Subject: **COLUMBIA GENERATING STATION (COLUMBIA) NATIONAL  
POLLUTANT DISCHARGE ELIMINATION SYSTEM (NPDES) PERMIT  
REISSUE, INTAKE STRUCTURE COMMENTS**

# **Why Cylindrical Screens in Flowing Water Impinge and Entrain Few Fish and Its Importance for The Columbia Generating Station's Intake**

**Comments on NMFS letter of December 12, 2013 to Shannon  
Khounnala of Energy Northwest by Michael P. Tehan of NMFS, with its  
Attached Memo**

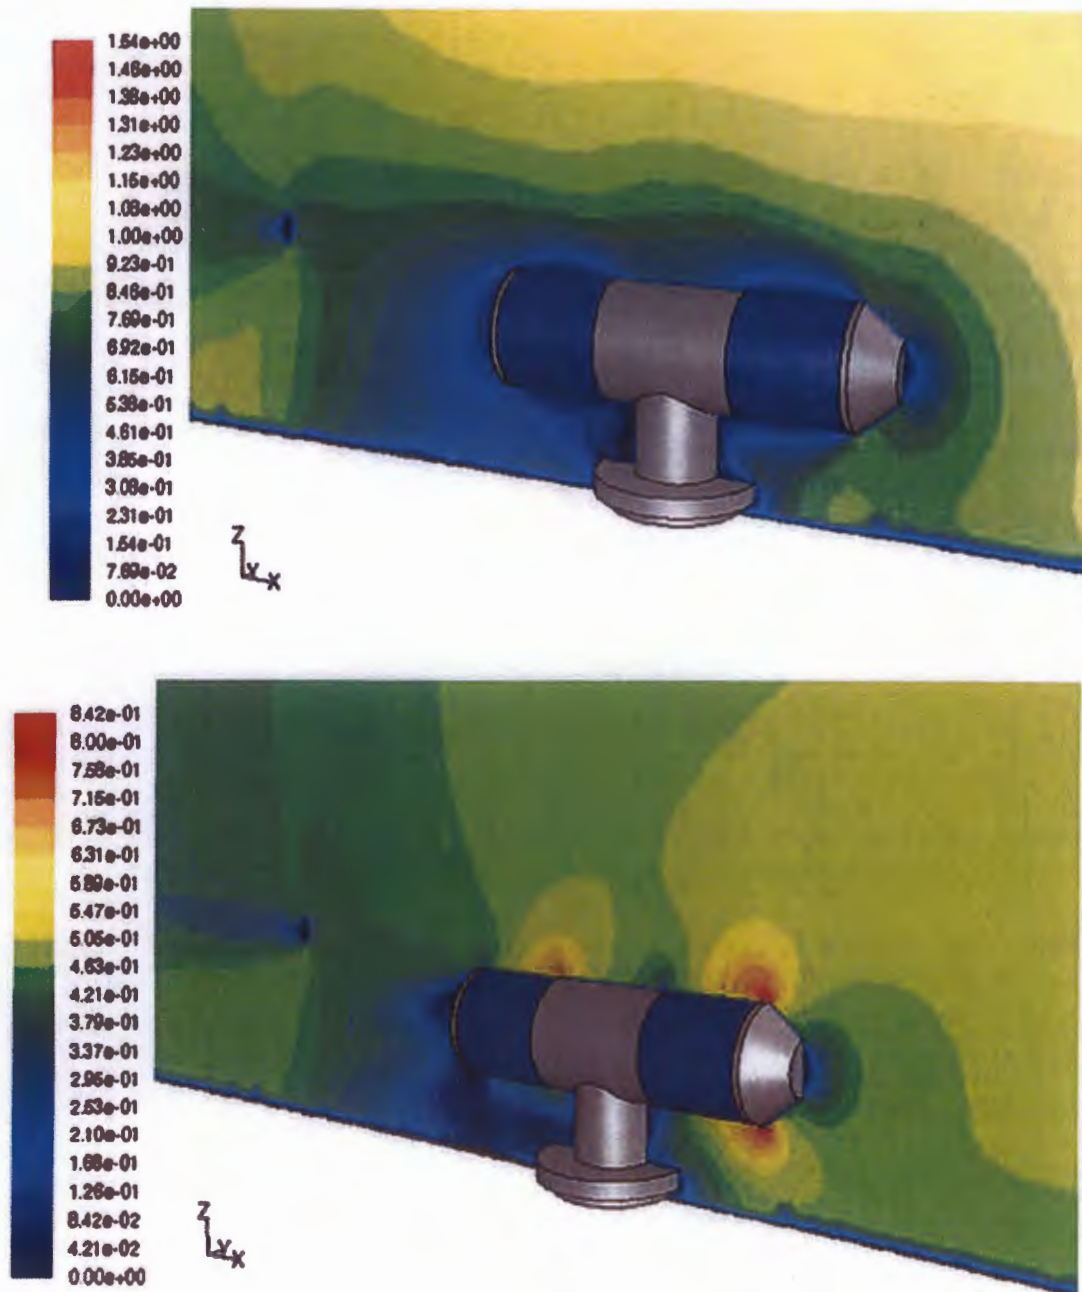
11) Figure 1 of the ENW report, which was a model study of the screen in the Alden flume, was shown for two purposes, one was to illustrate what happens to water flow at an example cylindrical screen, and the other to show what was actually studied at the Alden flume. From basic fluid dynamics, it would be generally representative of what happens to water flow at the CGS intake. Water flow does not equate to fish trajectory.

**Figure 4. Spare perforated-plate cylindrical intake screen (side view) for the Columbia Generating Station. This unit is one half of the completely assembled cylindrical screen and would be upstream or downstream of the vertical pipe leading to the pump house (see Figure 6).**

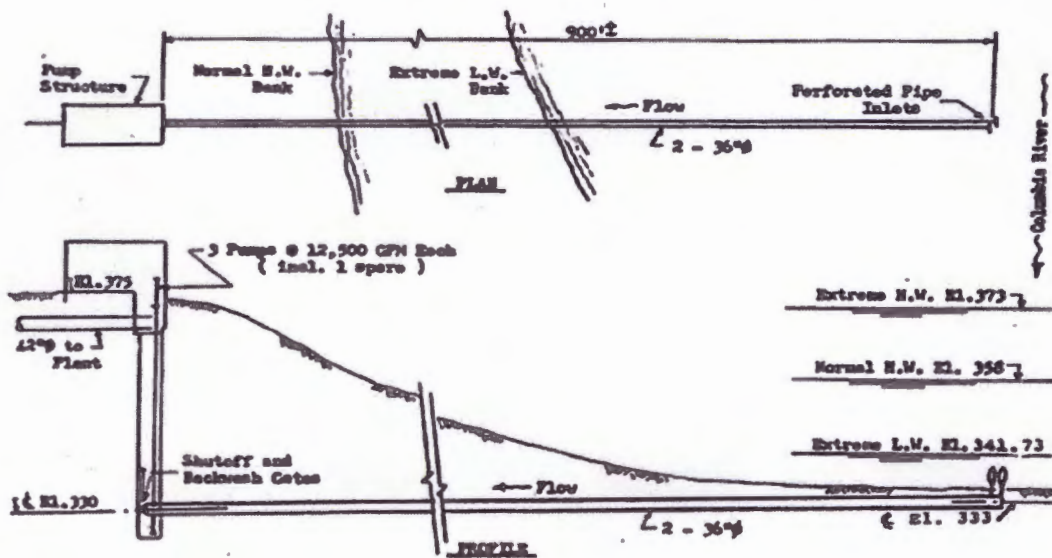
A pronounced null point that might be used as a fish refuge is unlikely. The CGS screens have a fairly pointed leading end (shown in Figure 4 of the discussion paper), which minimizes the occurrence of a null point (zone of very low velocity) associated with a blunt cylinder.
